**RE: West Central Complete Streets – Sarracino Pl to 98<sup>th</sup> St  
Preliminary Drainage Report – December 24, 2025  
Engineer’s Stamp Date: No Date  
Hydrology File: K09D045  
Case # HYDR-2026-00013**

Based upon the information provided in your submittal received 01/14/2026, the Preliminary Drainage Report **is not** approved for Work Order. The following comments need to be addressed for approval of the above referenced project:

# WEST CENTRAL COMPLETE STREETS SARRACINO PLACE TO 98<sup>TH</sup> STREET

PRELIMINARY DRAINAGE REPORT

## ALTERNATIVE #2 – STORM DRAIN

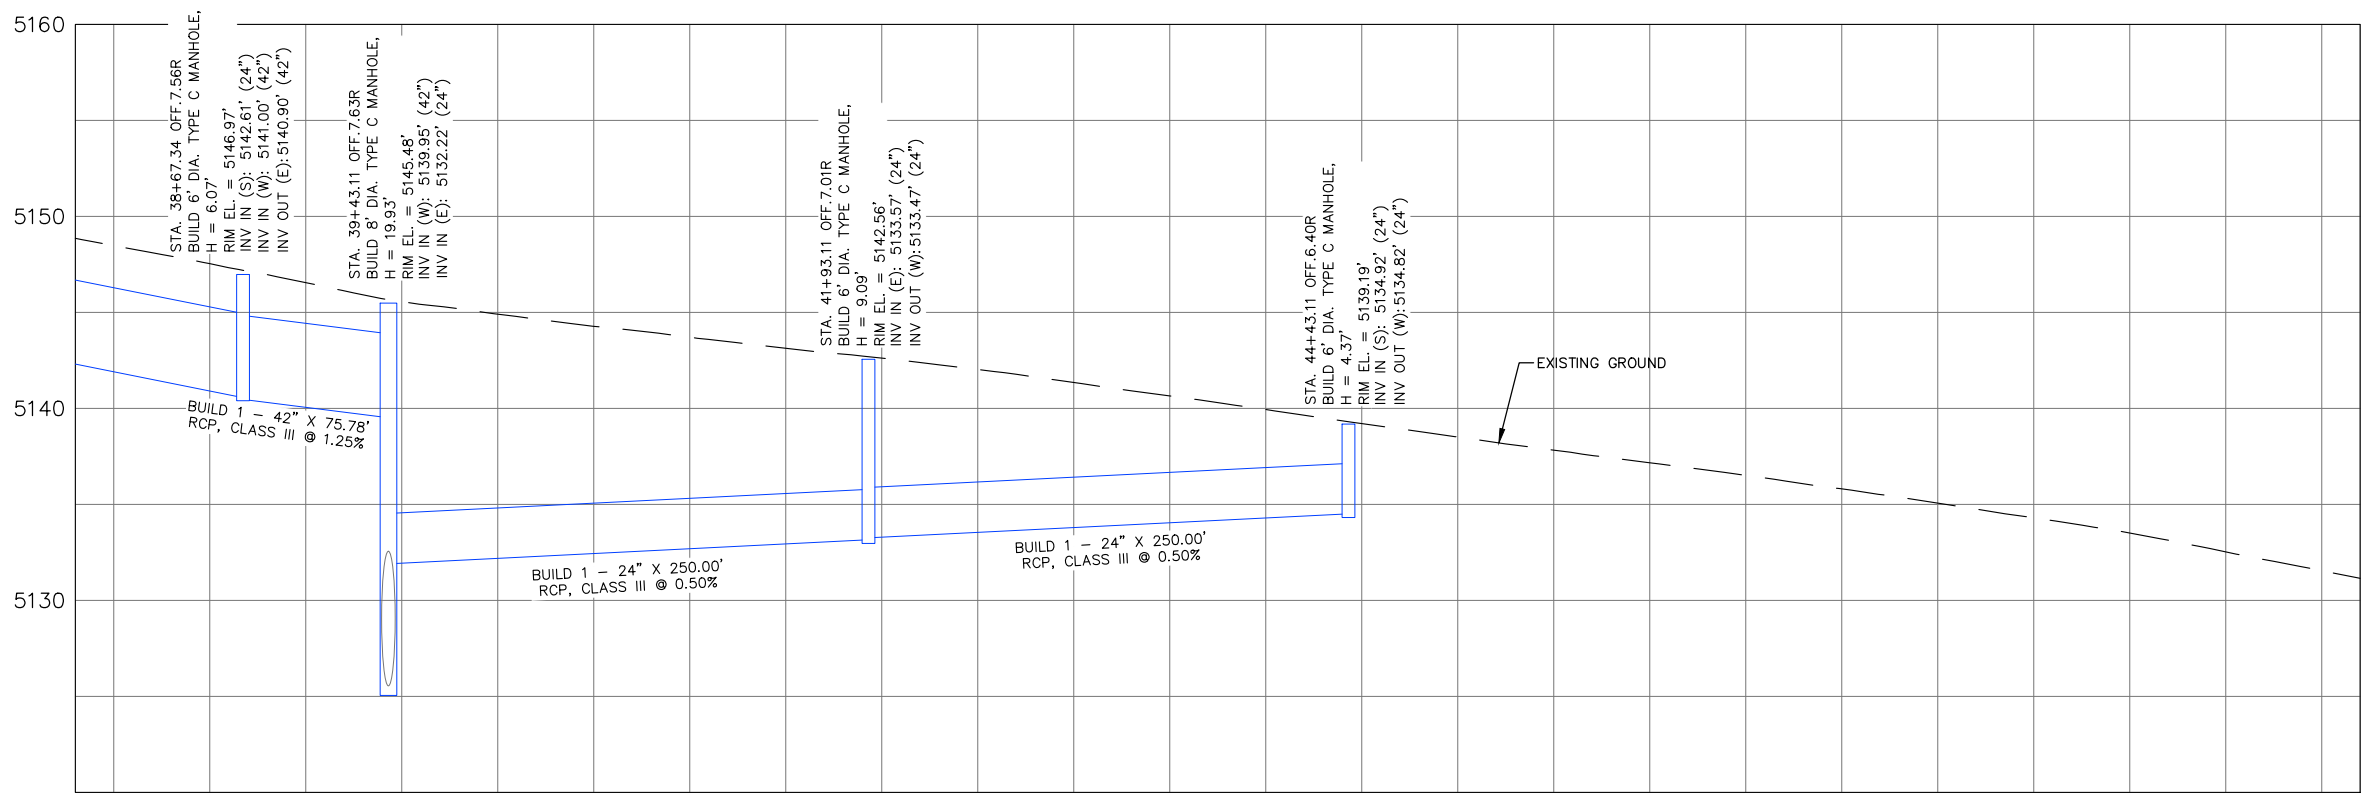
1. Please provide an engineer’s stamp with a signature and date.
2. Pg 68-71 – Add street names to the plan.
